APPLICATION NO.	FILING DATE	FIRST NAMED INVENTOR	ATTORNEY DOCKET NO.	CONFIRMATION NO.		
10/083,079	02/26/2002	Dominik Schutz	TRW(ASG)6052	4699		
26294	26294 7590 11/01/2004			EXAMINER		
TAROLLI, SUNDHEIM, COVELL & TUMMINO L.L.P. 526 SUPERIOR AVENUE, SUITE 1111 CLEVEVLAND, OH 44114			LUONG, VINH			
			ART UNIT	PAPER NUMBER		
	,		3682			
			DATE MAILED: 11/01/2004

Office Action Summary		Applica	tion No.	Applicant(s)				
		10/083,	079	SCHUTZ, DOMINIK	2			
		Examin	er	Art Unit				
		Vinh T L	uong	3682				
Period fo	The MAILING DATE of this communic or Reply	ation appears on t	he cover sheet with the c	orrespondence address				
THE - Exte after - If the - If NC - Failt Any	ORTENED STATUTORY PERIOD FO MAILING DATE OF THIS COMMUNIC nsions of time may be available under the provisions of SIX (6) MONTHS from the mailing date of this communication period for reply specified above, the maximum state of the reply within the set or extended period for reply within the set or extended period for reply within the set or extended period for reply wreply received by the Office later than three months after the patent term adjustment. See 37 CFR 1.704(b).	CATION. f 37 CFR 1.136(a). In no nication.

ATTACHMENT # 1

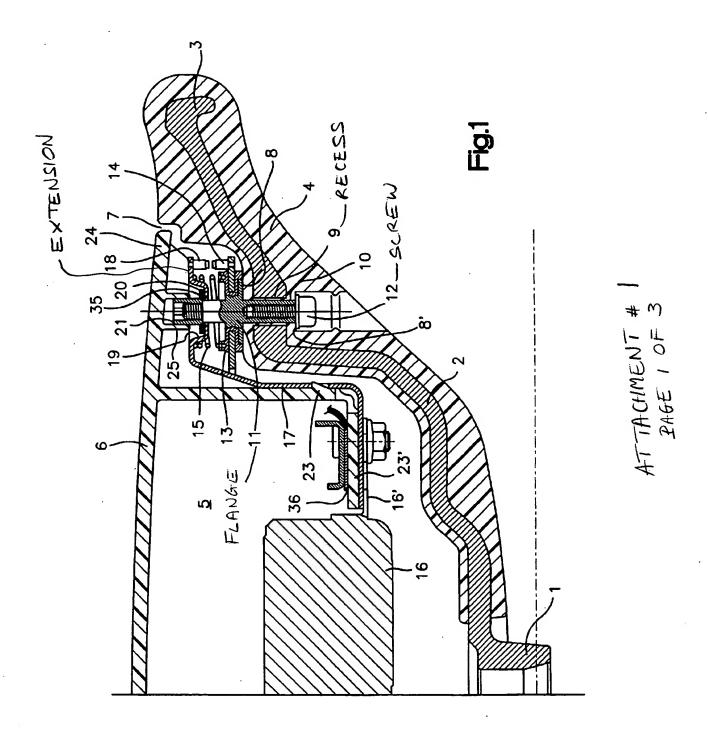
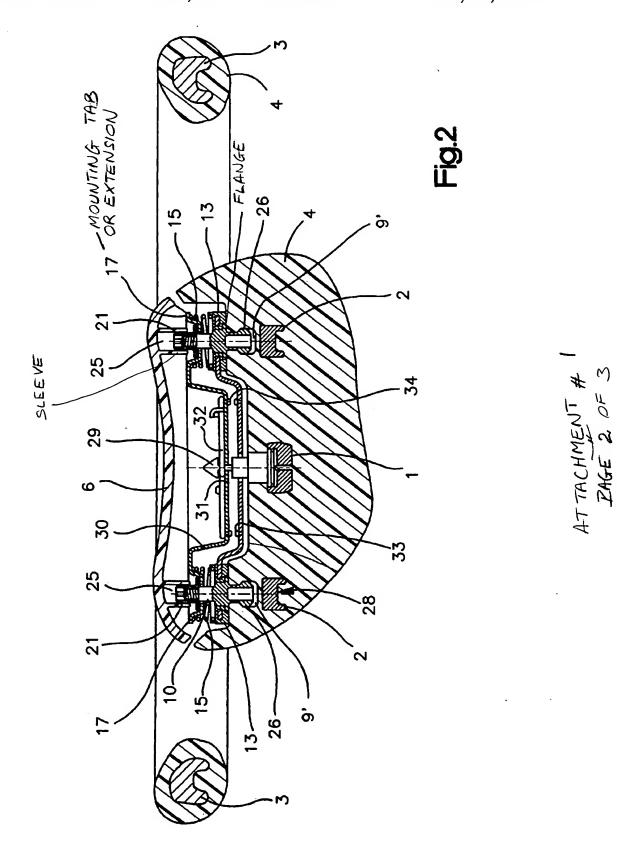
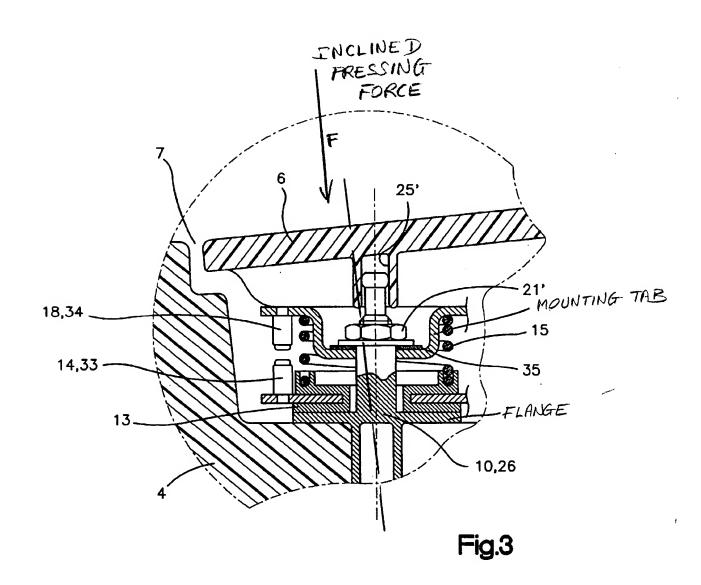
Regarding claim 3, said housing 17 is cup-shaped which is open towards said covering cap 6 and adapted to receive said gas bag 5, an edge of said receiving housing 17 has extensions 17 (Attachment # 1) projecting laterally outwards and towards said edge of said covering cap 6, said guides 10 or 10, 26 are provided on said extensions 17.

Fourth, Applicant contends that the bolt is still in a fixed axial direction and provides a fixed abutment for the mounting tab 17 to tilt about. However, Fig. 2 of Bohn shows that the guide 10 is projected out of the tab 17. Therefore, the guide 10 is tilted with the tab 17 as shown in Bohn's Fig. 2 and as Applicant admitted in the Amendment filed on July 30, 2003.

with the law of physics. In fact, Bohn's Fig. 3 shows that when Bohn's edge 24 of the covering cap 6 is depressed, the sleeve 25' will tilt and the bolt 10, 26 will be tilted therewith because the head of the bolt is within the sleeve 25'. Therefore, Bohn's blot is guided by Bohn's sleeve 25. In the same manner, Applicant's bolt 32 is guided by Applicant's sleeve as seen in Figs. 4a and 4b of Attachment # 2.

ATTACHMENT # 2

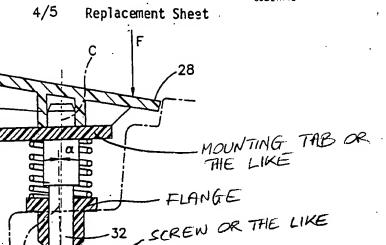
On the other hand, if a person of ordinary skill in the art would recognize that flange 11 and screw 12 of Bohn prevent tilting and axial movement of bolt 10 of Bohn as Applicant alleges, said person of ordinary skill would also recognize that Applicant's flange and screw (or the like as shown in Attachment #2) prevent tilting and axial movement of Applicant's bolt 32.

Nevertheless, Applicant's bolts 32 are also provided with an extremely large area of contact and braced against movement by a screw or the like at their outermost ends as seen in Attachment # 2. Therefore, if one applies sufficient force on Bohn's cap 6 at the head areas of Bohn's bolts 10, the bolts 10 will move or tilt as admitted by Applicant in the Amendment filed on July 30, 2003. In other words, Bohn's casing is made of foamed material does necessarily imply that it is flexible enough so that the bolts 10 provided with an extremely large area of contact and braced against movement by a screw 12 will move a noticeable amount when force is transmitted to them by pressing on the covering cap 6 to actuate the horn. In re King and In re Merk & Co., Inc., supra.
